# BLYTHE MESA SOLAR PROJECT

## Final Environmental Impact Report/Environmental Assessment

### Volume V: Technical Appendices

### RESPONSE TO COMMENTS

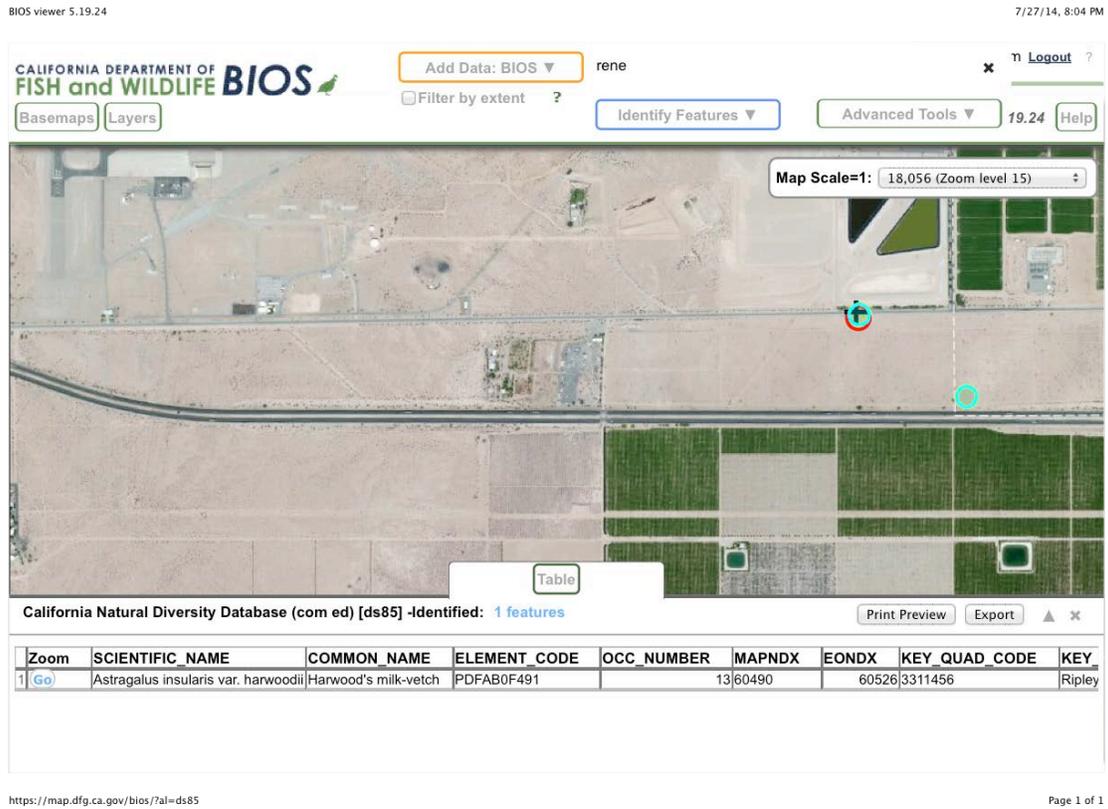
Harwood's woollystar (*Eriastrum harwoodii*) occurs within all three potential gen-tie corridors.<sup>1</sup> Harwood's milk-vetch (*Astragalus insularis* var. *harwoodii*) occurs on the Project site (Figure 1) and within the northern gen-tie line corridor.<sup>2</sup> Harwood's woollystar has a Rare Plant Rank of 1B.2, which indicates it is rare throughout its range and fairly endangered in California.<sup>3</sup> The species has a global rank of G2 and a state rank of S2, which indicates it is "at high risk of extinction due to very restricted range, very few populations (often 20 or fewer), steep declines, or other factors" at both the statewide and global scale.<sup>4</sup> Harwood's milk-vetch has a Rare Plant Rank of 2.2, which indicates it is rare or endangered in California, but more common elsewhere.<sup>5</sup> The species has a state rank of "S2.2?," which represents slightly less certainty than a rank of S2.<sup>6</sup>

Figure 5. Ponds adjacent to the boundary (yellow line) of the northern portion of the Project site.

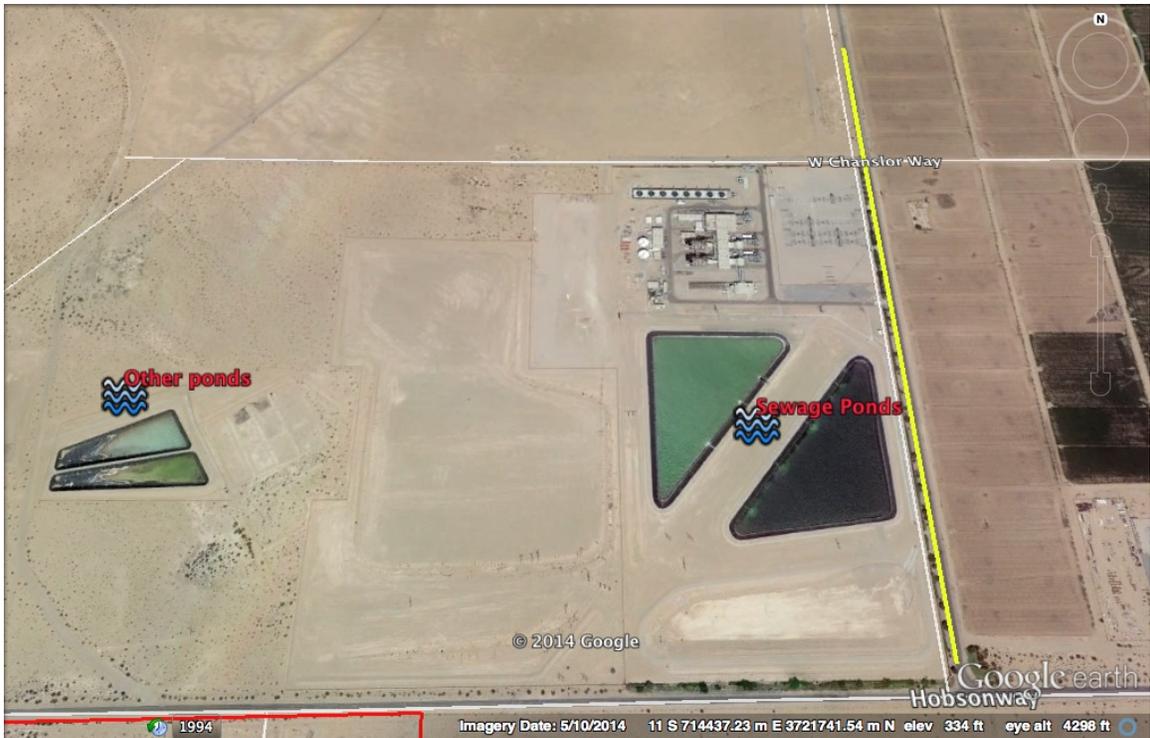
Although the Project will not have evaporation ponds, the northern portion of the Project site is located immediately adjacent to two sewage treatment ponds, and two other ponds of unknown use (Figure 5). Sewage treatment ponds are known to attract an abundance of birds due to the food they supply.<sup>52</sup> Based on my calculations, the sewage treatment

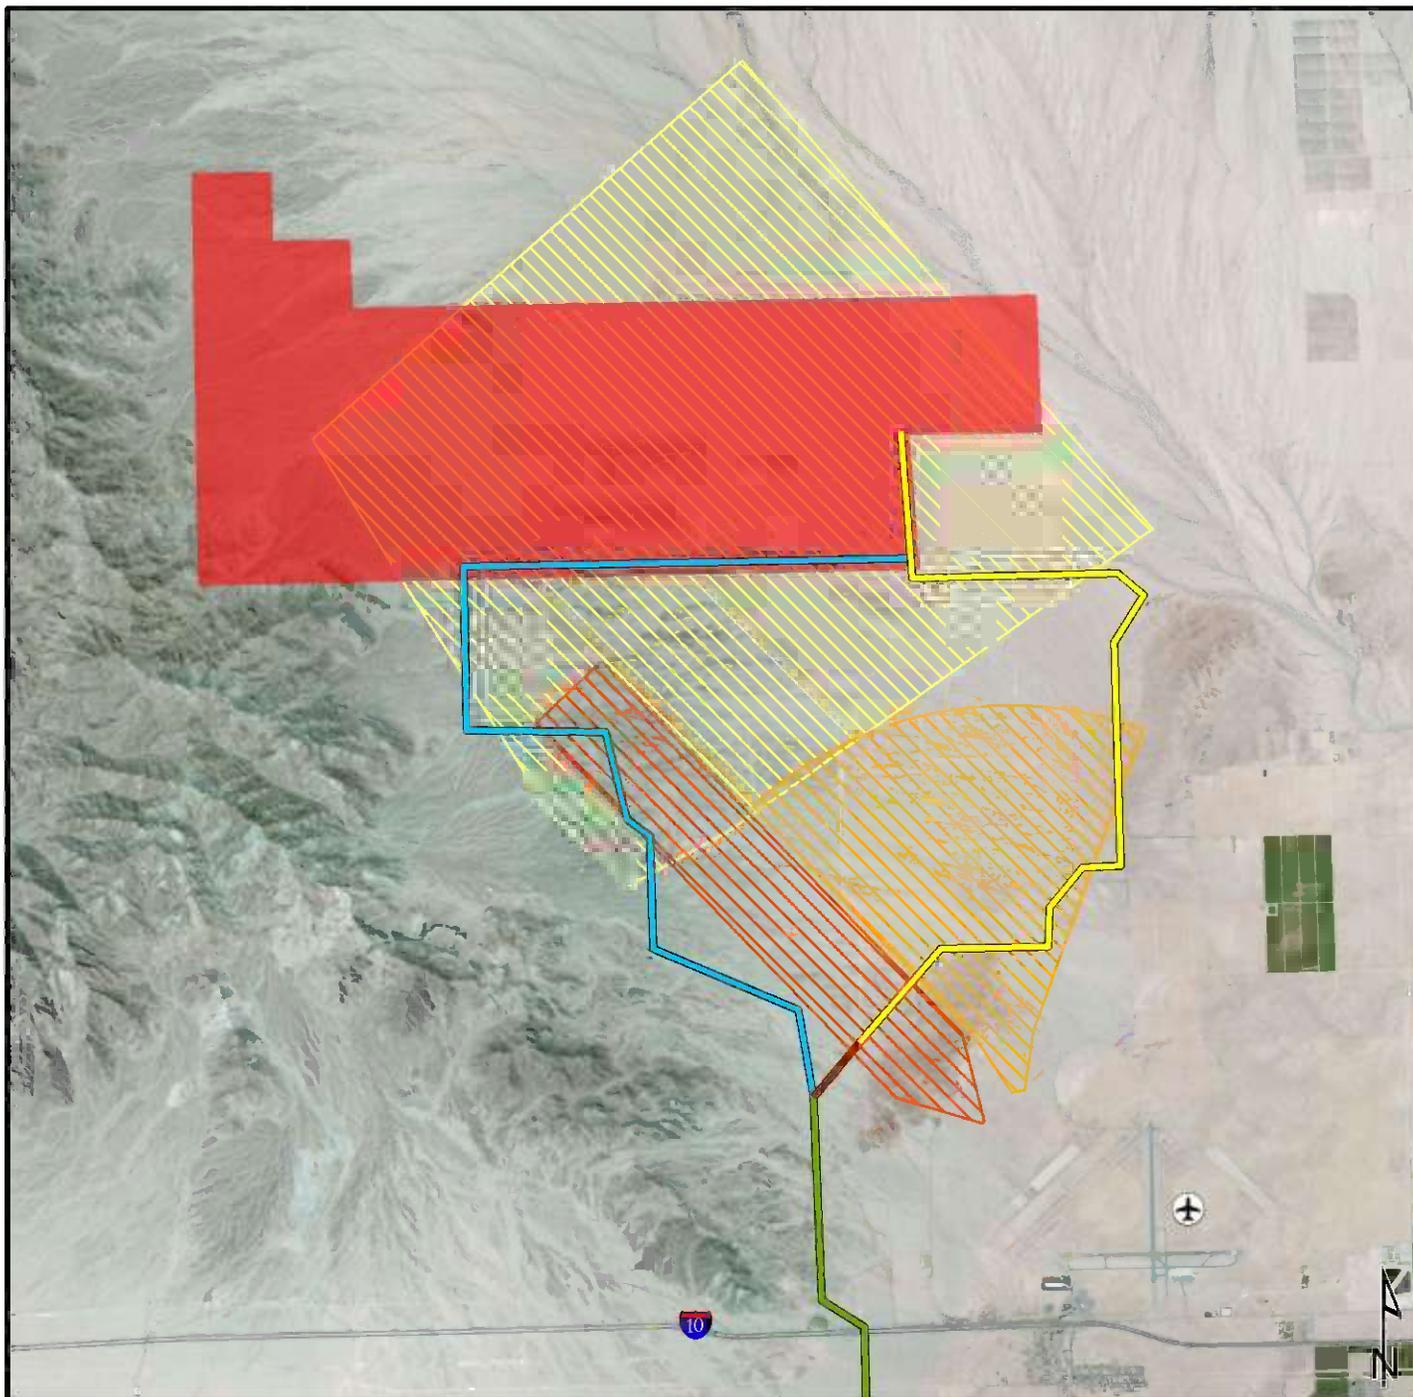
We have mapped the FUDs boundary and associated features including firing ranges and a practice bombing area (Figure 1, Attachment A). As shown in the figure, areas where bullets were scattered from target practice (known as "safety fans") are located approximately 4000 feet south of the Project site footprint. Tie lines for power transmission cut across both safety fans. The practice bombing range underlies a majority of the Project area.

guns. The safety fan associated with the Poorman Range at the Blythe AAF is shown in Figure 1 to extend more than five miles to underlie the eastern and western generator tie line alignments being considered for power transmission lines.

Jeep Ranges were used to simulate moving targets for trainees using .30 and .50 caliber machine guns. The Jeeps were guided on tracks behind an earthen bunker with the target extending above the berm.<sup>15</sup> Figure 1 shows the Jeep Range to underlie the eastern generator tie line alignment and an access road.

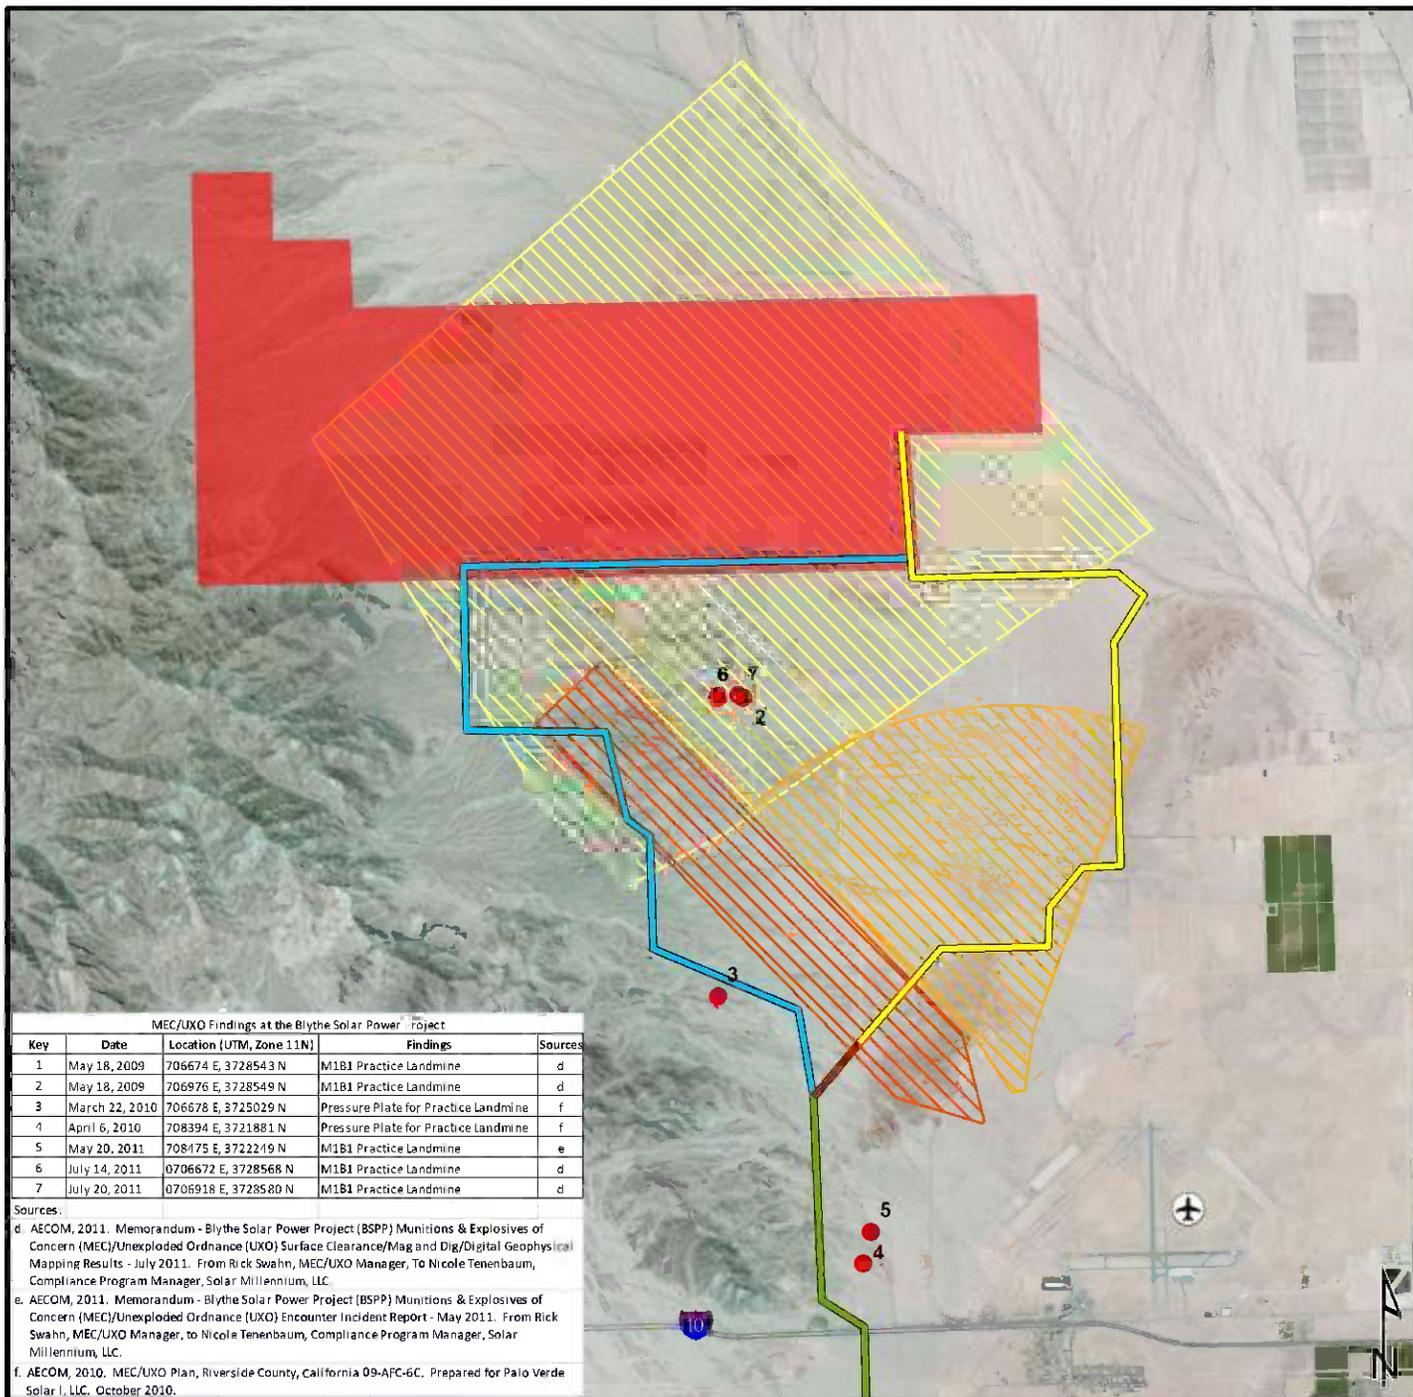
UXO has been documented in association with the neighboring Blythe Solar Power Project (BSPP), located within less than 500 feet south of the Project site. During construction of the BSPP, seven separate UXO-related material findings have been reported. These incidents are documented in Monthly Compliance Reports and associated attachments, which were prepared by the applicant and submitted to the California Energy Commission. We obtained these reports and have created a map to show where UXO have been found (Figure 2, Attachment B). These findings are also described in the table below.

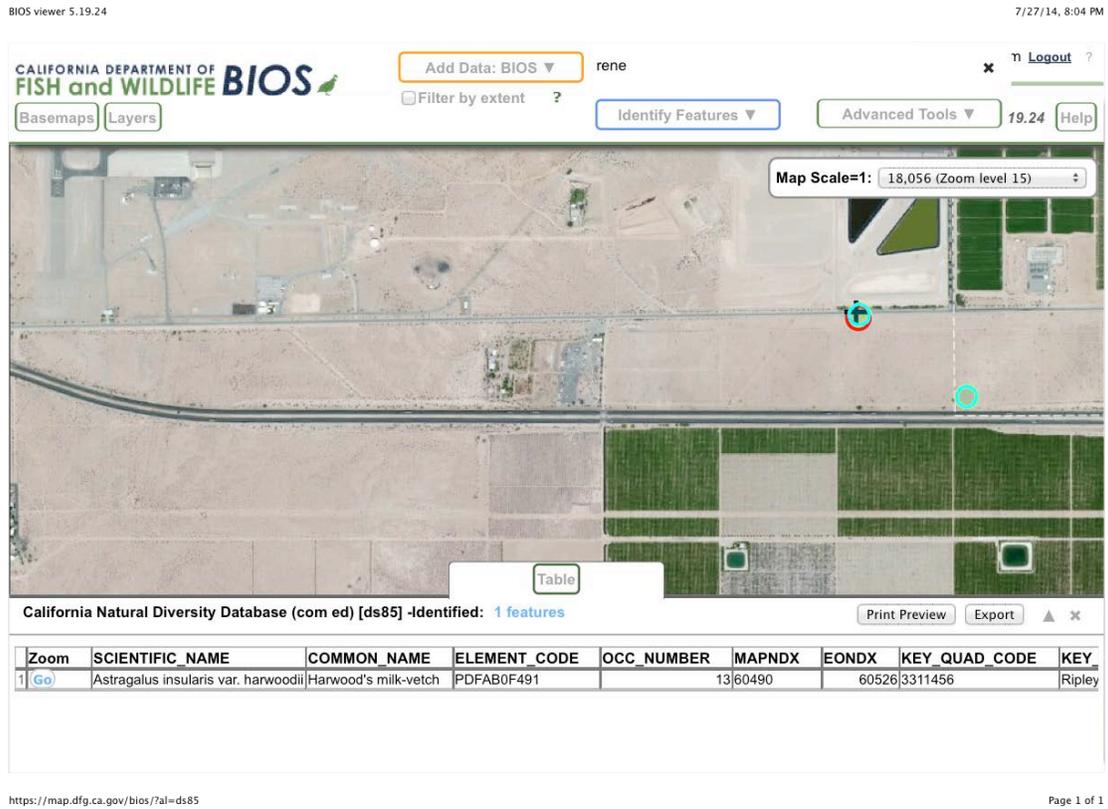
Harwood's woollystar (*Eriastrum harwoodii*) occurs within all three potential gen-tie corridors.<sup>1</sup> Harwood's milk-vetch (*Astragalus insularis* var. *harwoodii*) occurs on the Project site (Figure 1) and within the northern gen-tie line corridor.<sup>2</sup> Harwood's woollystar has a Rare Plant Rank of 1B.2, which indicates it is rare throughout its range and fairly endangered in California.<sup>3</sup> The species has a global rank of G2 and a state rank of S2, which indicates it is "at high risk of extinction due to very restricted range, very few populations (often 20 or fewer), steep declines, or other factors" at both the statewide and global scale.<sup>4</sup> Harwood's milk-vetch has a Rare Plant Rank of 2.2, which indicates it is rare or endangered in California, but more common elsewhere.<sup>5</sup> The species has a state rank of "S2.2?," which represents slightly less certainty than a rank of S2.<sup>6</sup>

Figure 5. Ponds adjacent to the boundary (yellow line) of the northern portion of the Project site.

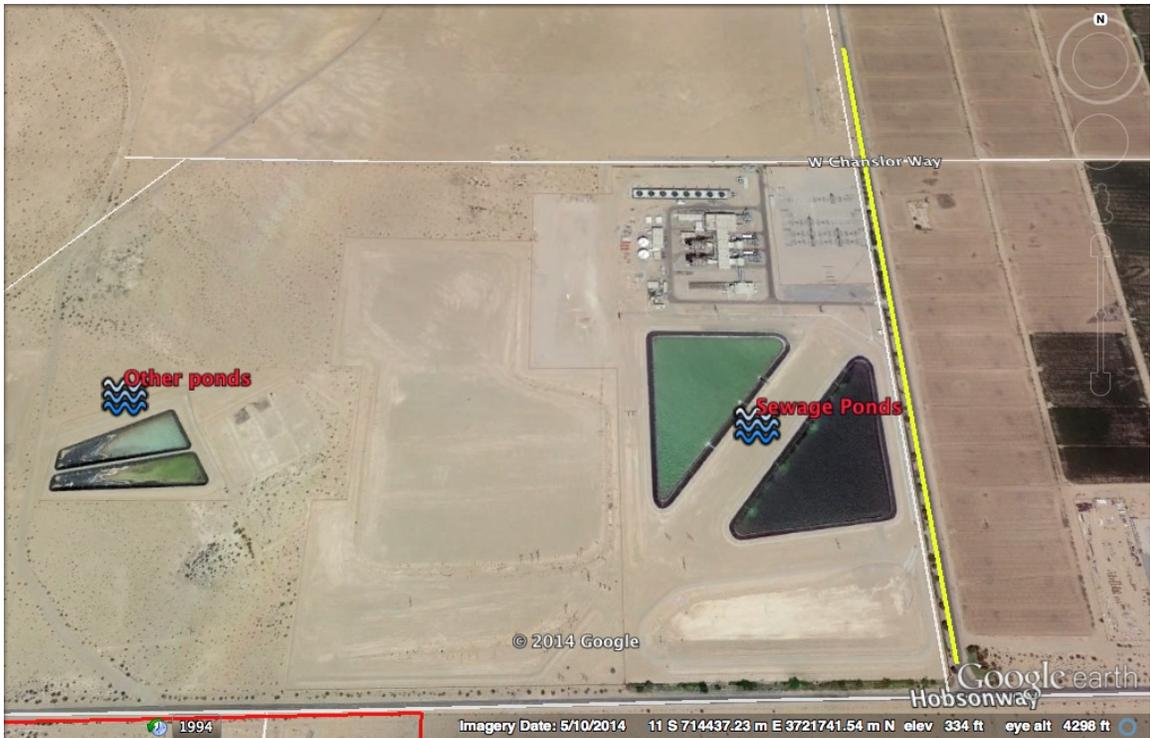
Although the Project will not have evaporation ponds, the northern portion of the Project site is located immediately adjacent to two sewage treatment ponds, and two other ponds of unknown use (Figure 5). Sewage treatment ponds are known to attract an abundance of birds due to the food they supply.<sup>52</sup> Based on my calculations, the sewage treatment

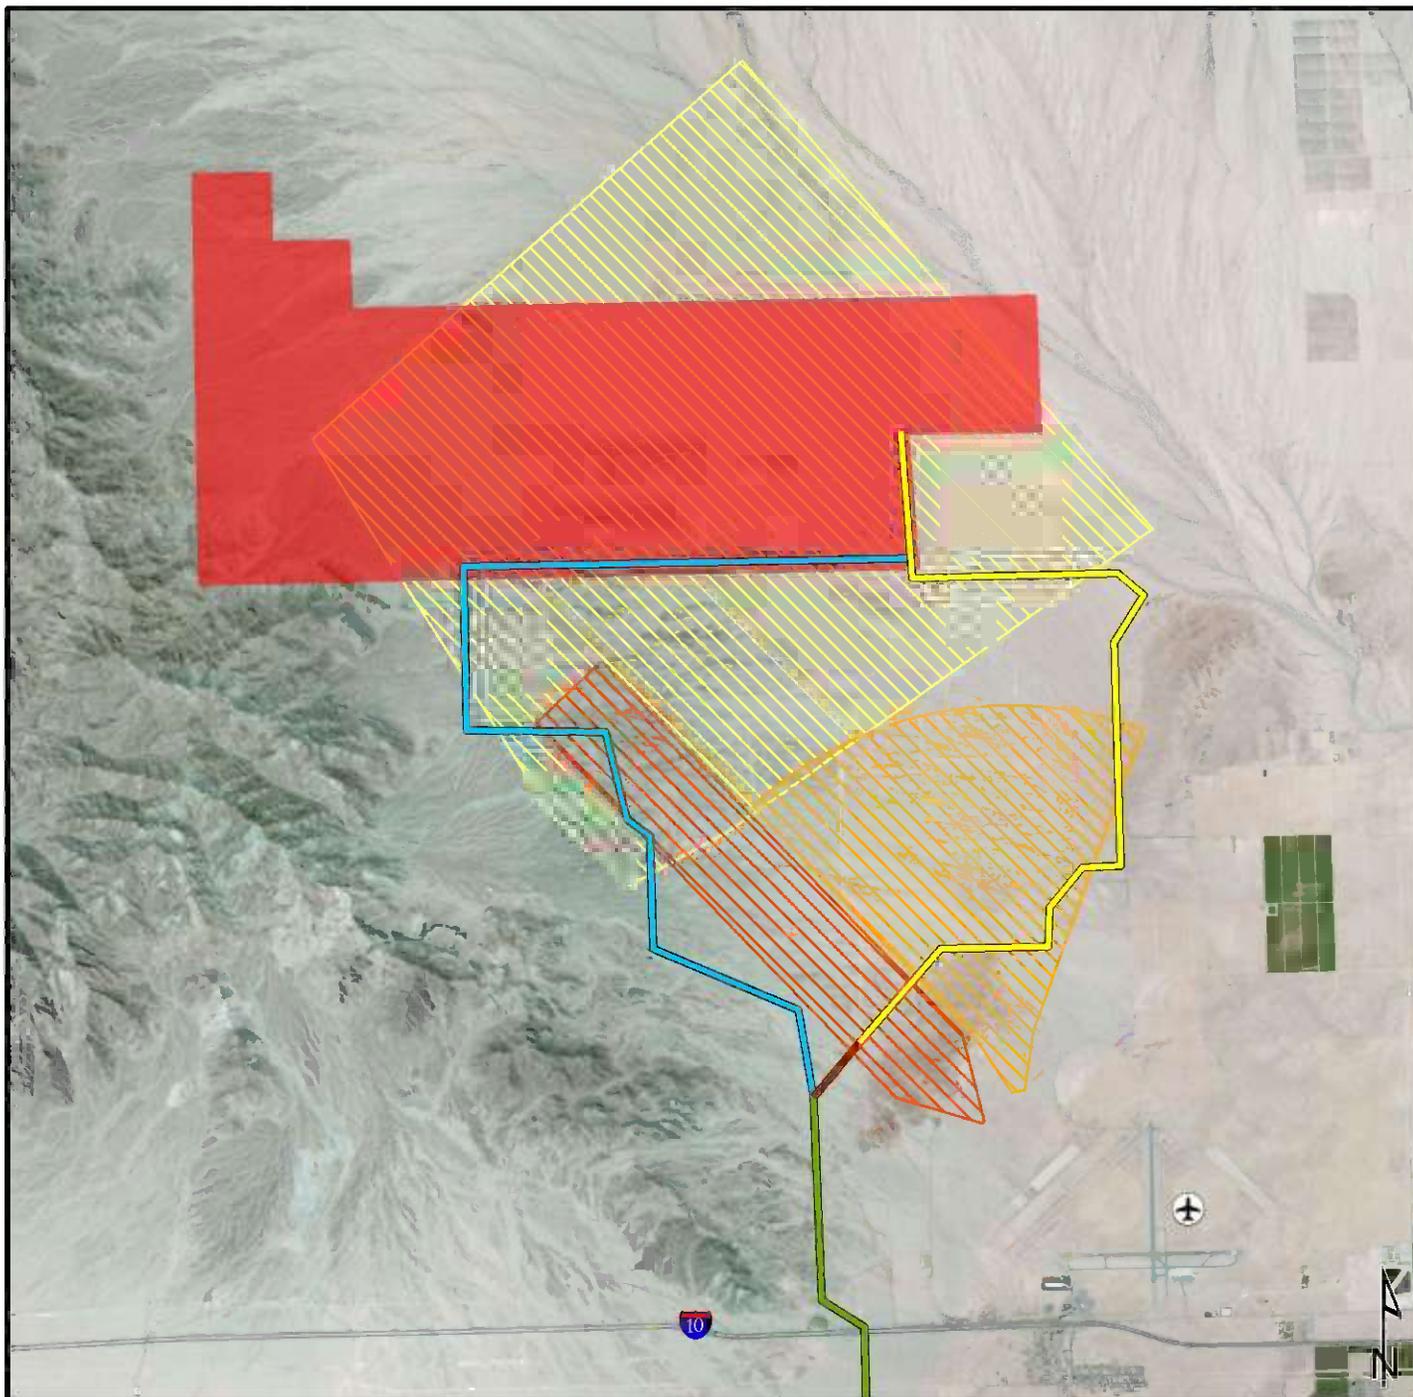
We have mapped the FUDs boundary and associated features including firing ranges and a practice bombing area (Figure 1, Attachment A). As shown in the figure, areas where bullets were scattered from target practice (known as "safety fans") are located approximately 4000 feet south of the Project site footprint. Tie lines for power transmission cut across both safety fans. The practice bombing range underlies a majority of the Project area.

guns. The safety fan associated with the Poorman Range at the Blythe AAF is shown in Figure 1 to extend more than five miles to underlie the eastern and western generator tie line alignments being considered for power transmission lines.

Jeep Ranges were used to simulate moving targets for trainees using .30 and .50 caliber machine guns. The Jeeps were guided on tracks behind an earthen bunker with the target extending above the berm.<sup>15</sup> Figure 1 shows the Jeep Range to underlie the eastern generator tie line alignment and an access road.
